HISTORIC AND DESIGN REVIEW COMMISSION

December 21, 2022

HDRC CASE NO: 2022-574
ADDRESS: 145 NAVARRO ST
LEGAL DESCRIPTION: NCB 986 LOT 11 THRU 13 AND E 5.14FT OF 10
ZONING: D, H, RIO-3
CITY COUNCIL DIST.: 1
APPLICANT: Peter Ketter/Sandvick Architects Inc.
OWNER: Kunal Mody/145 NAVARRO LLC
TYPE OF WORK: Construction of a rooftop addition, fenestration modifications, window replacement, rehabilitation, canopy installation and signage
APPLICATION RECEIVED: December 02, 2022
60-DAY REVIEW: Not applicable due to City Council Emergency Orders
CASE MANAGER: Edward Hall
REQUEST:

Proposed Exterior Alterations
HDRC Conceptual Review – December 2022

TITLE:
Existing / Proposed Window Details

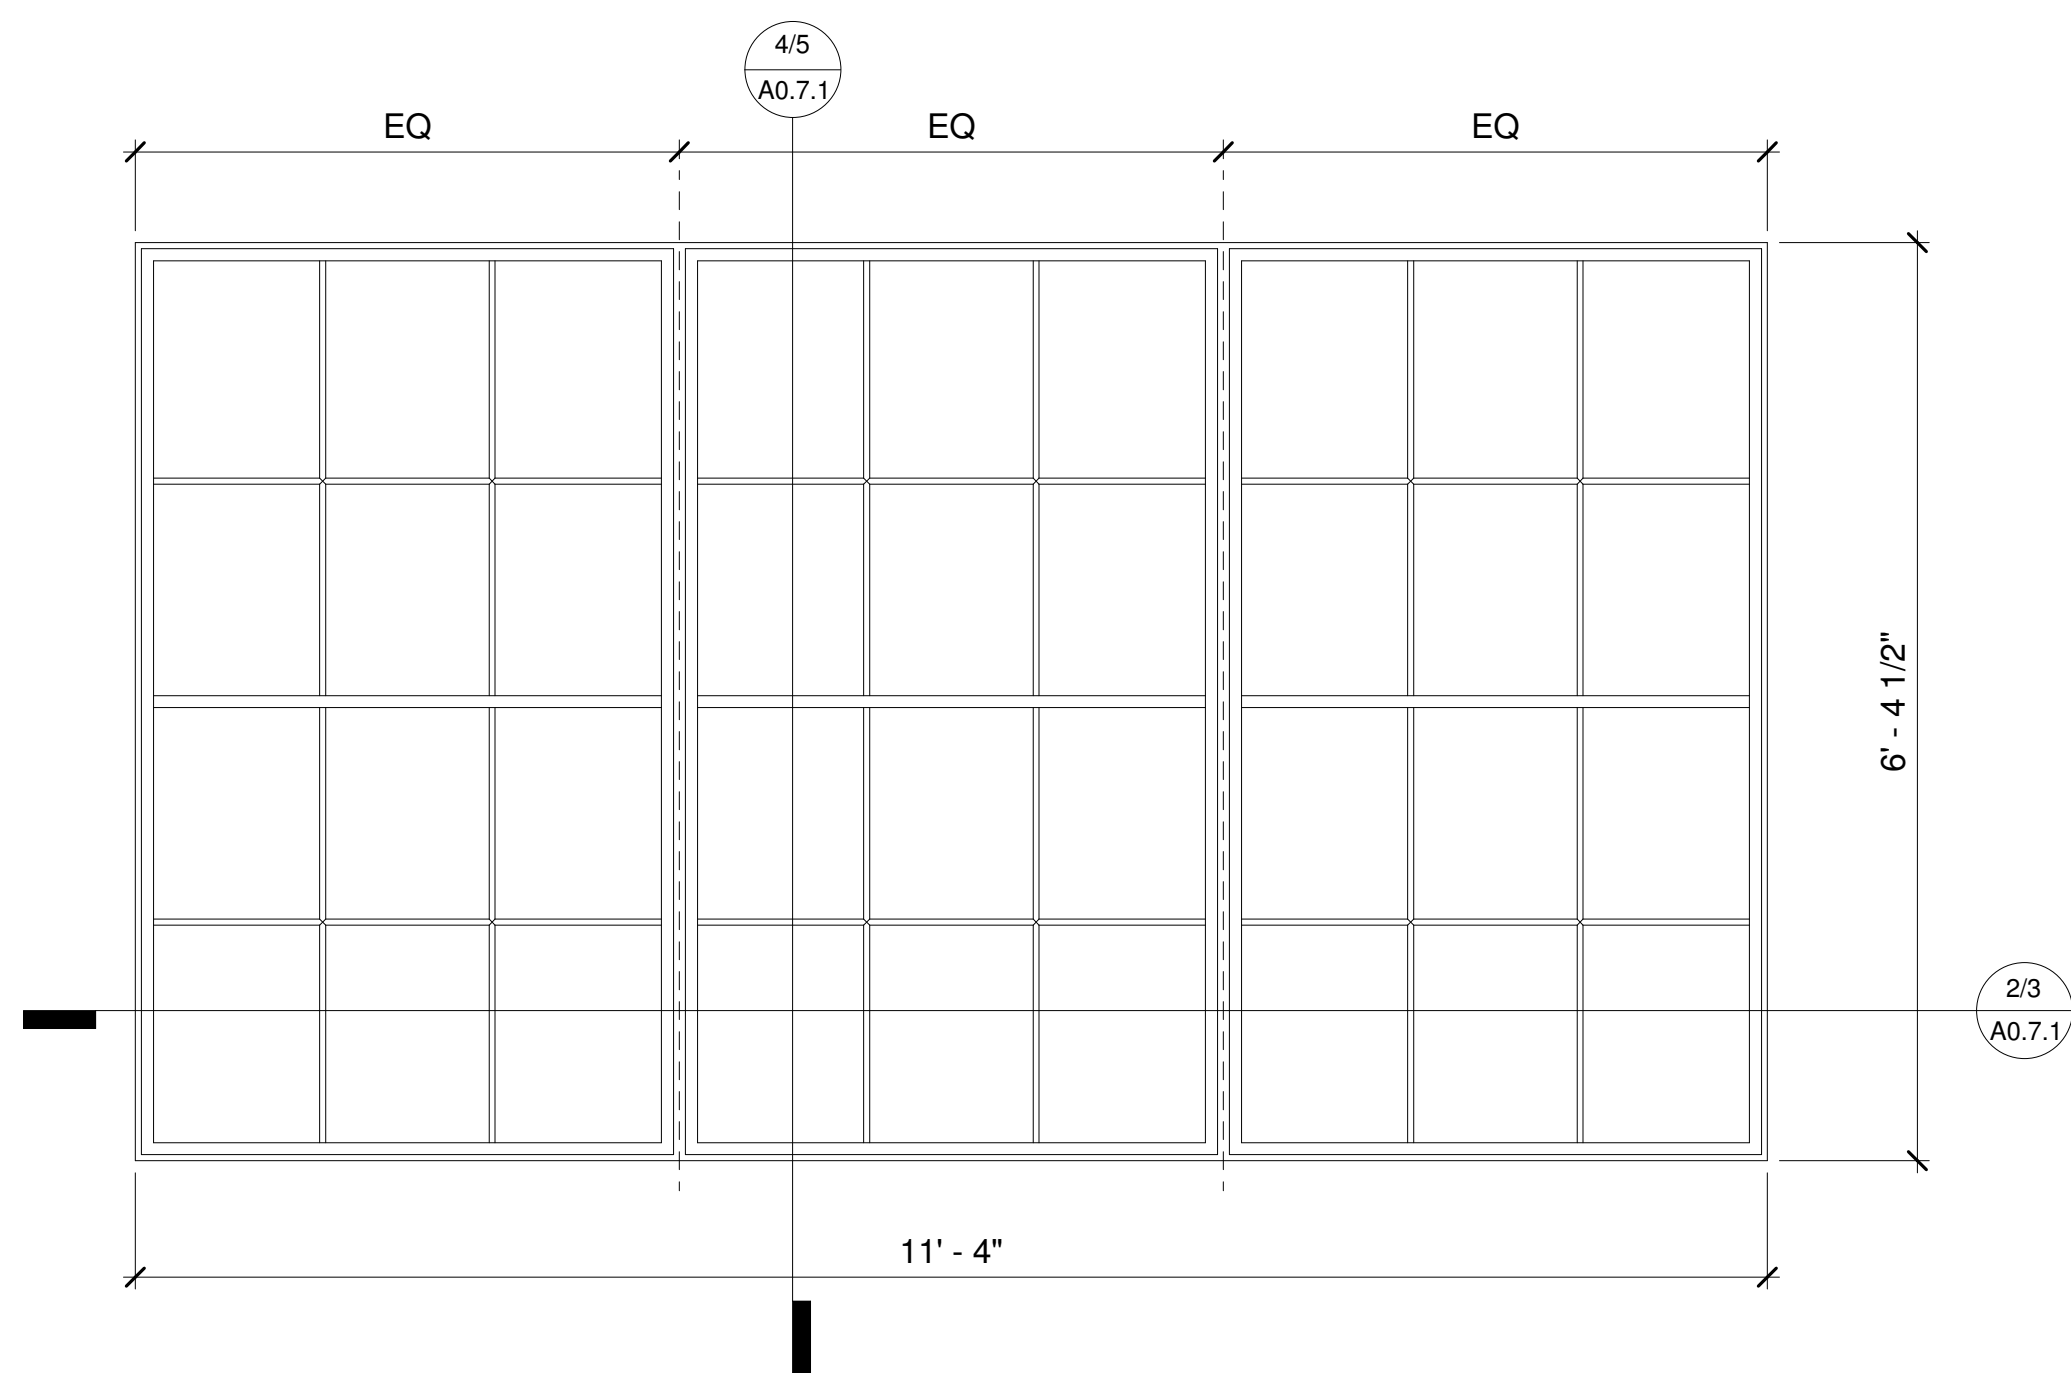
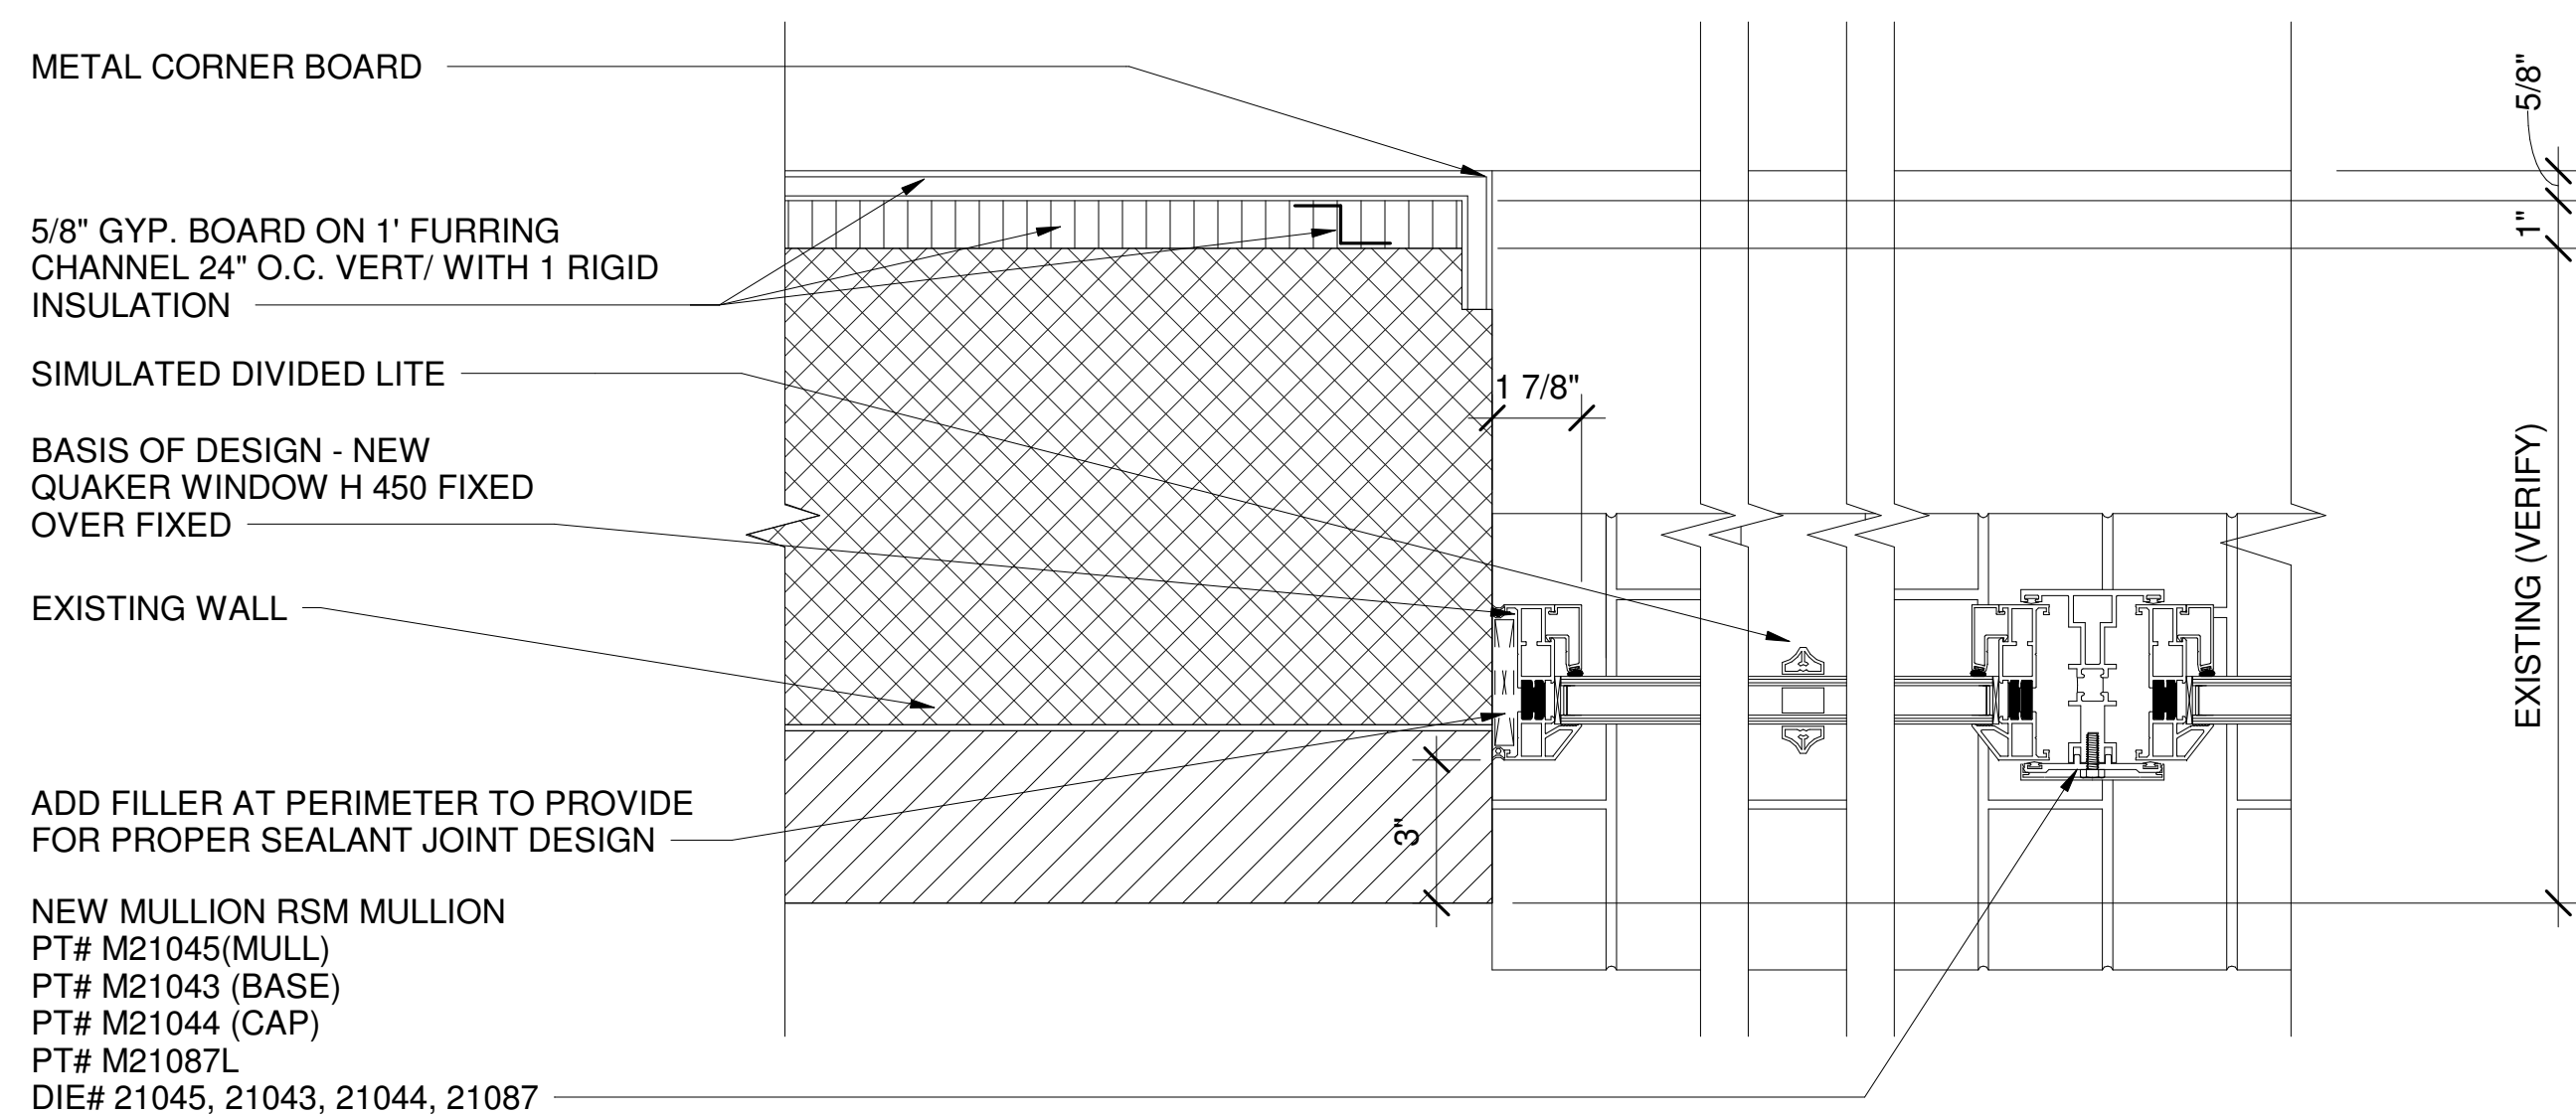
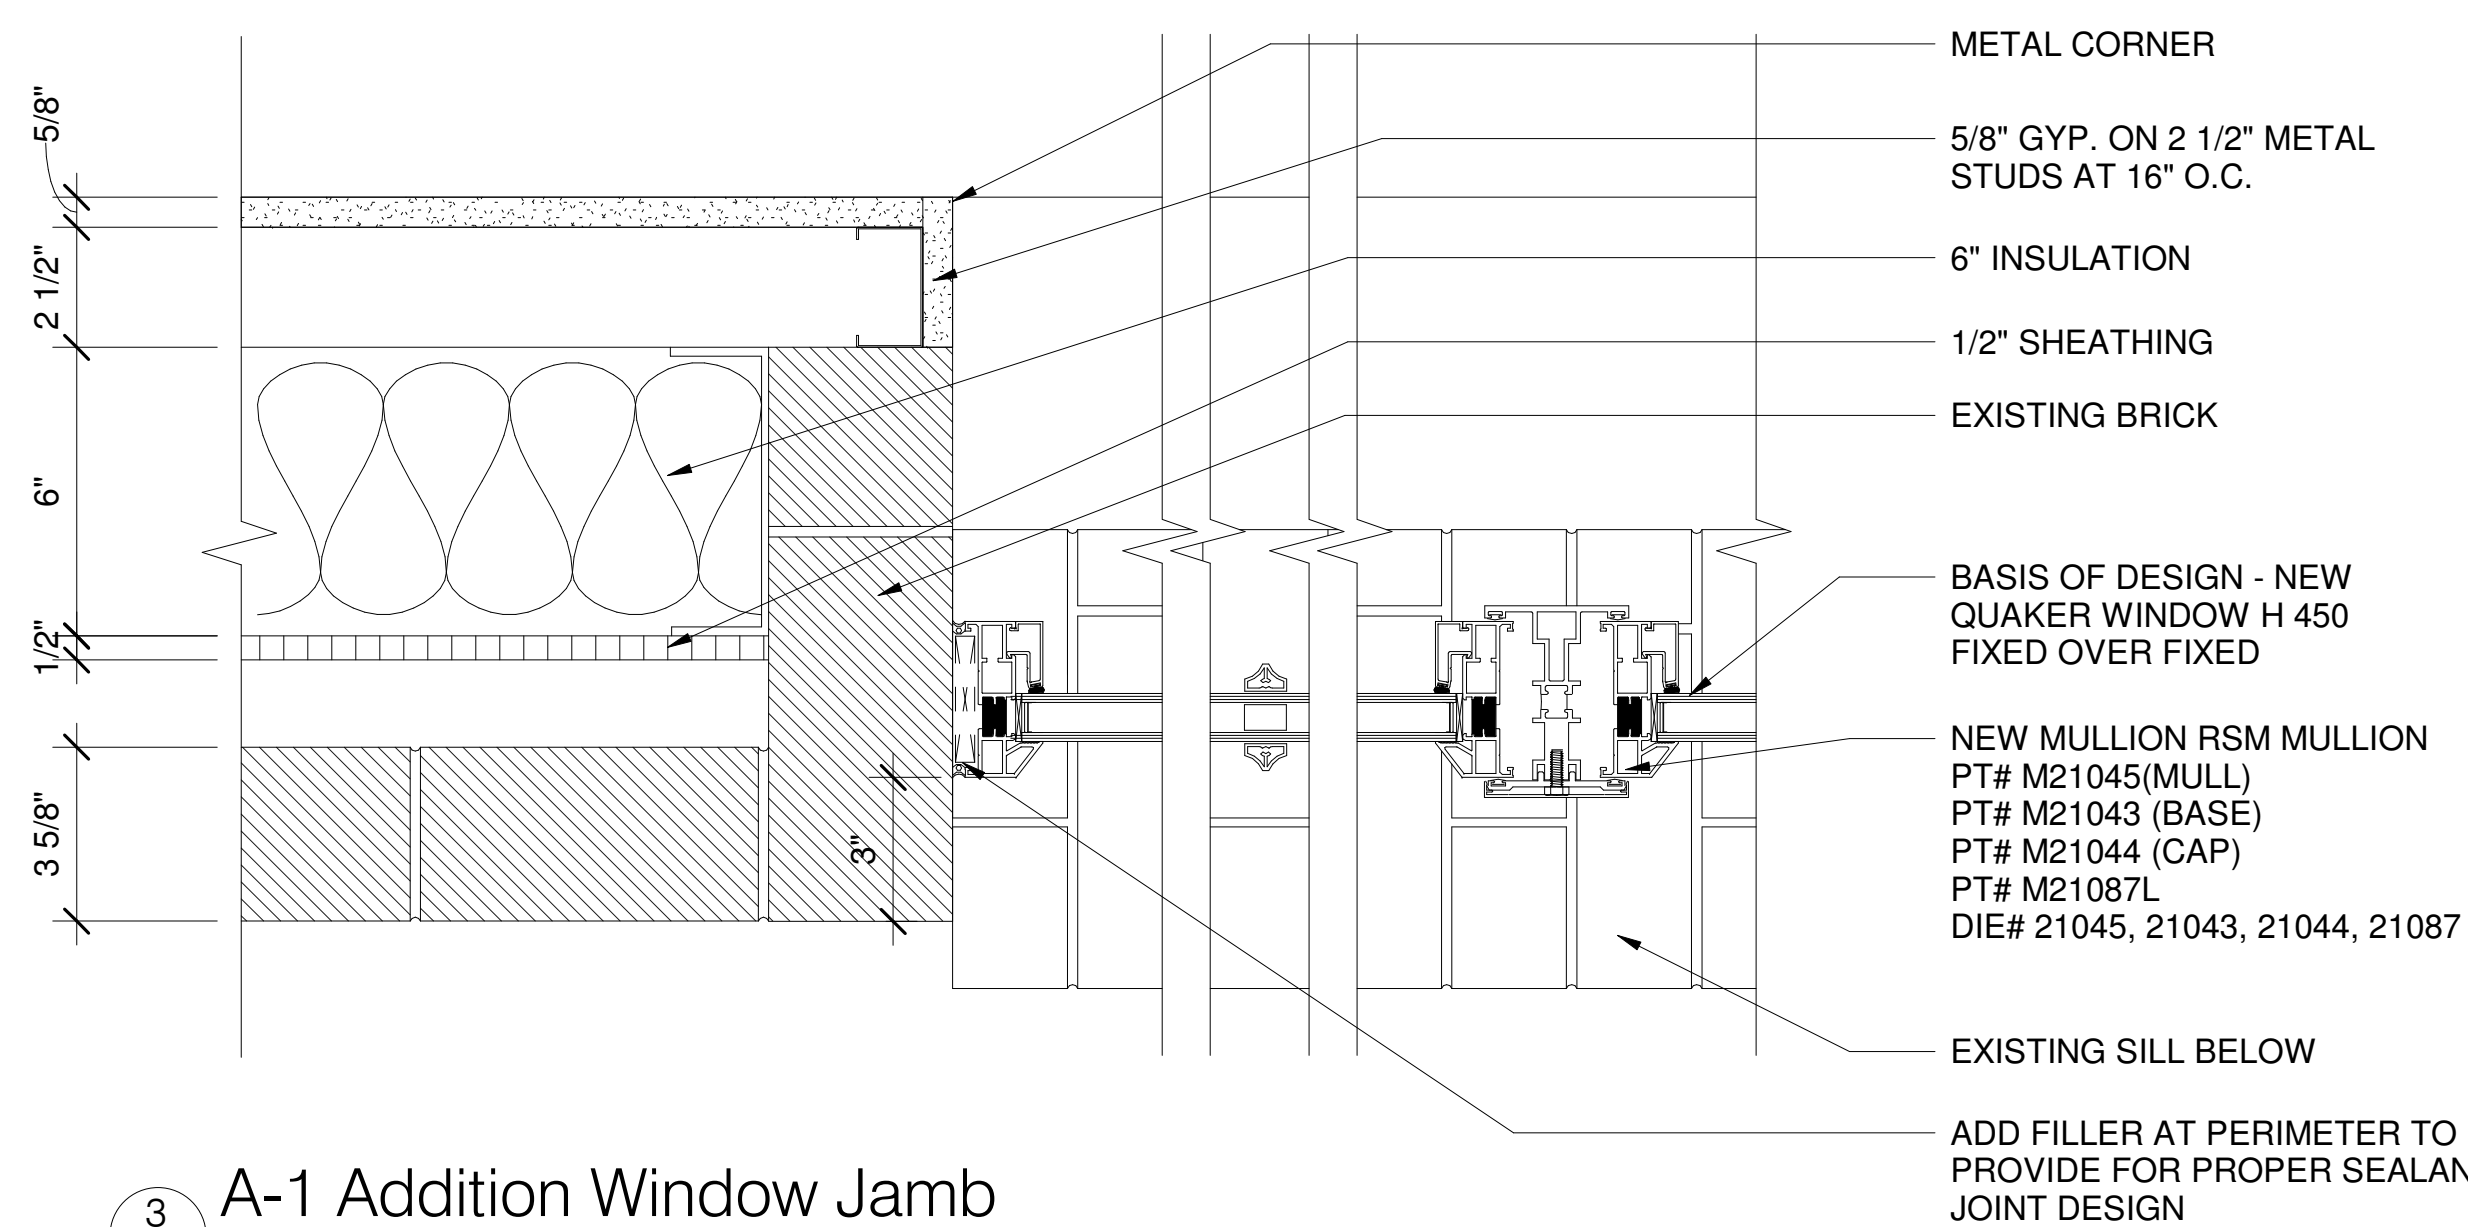
- d. **WINDOW REPLACEMENT** – The applicant has proposed to replace the existing, non-original windows with new, aluminum windows. Historic photos show steel windows featuring a six over six profile. Per historic photos, the original windows were operable. The existing, aluminum windows feature four, single panes. The applicant has proposed aluminum replacement windows that will feature simulated divided lite windows;

however, the proposed simulations will be both internal and external to window panes. The applicant has noted that the proposed windows will also feature true muntins and sloped windows sills. Generally, staff finds the proposed replacement windows to be appropriate; however, staff finds that windows should feature dark colored frames and window components.

- i. That window frames and their components feature dark colors.
3. Staff recommends approval of item #3, storefront system replacement, based on finding e, with the following stipulation:
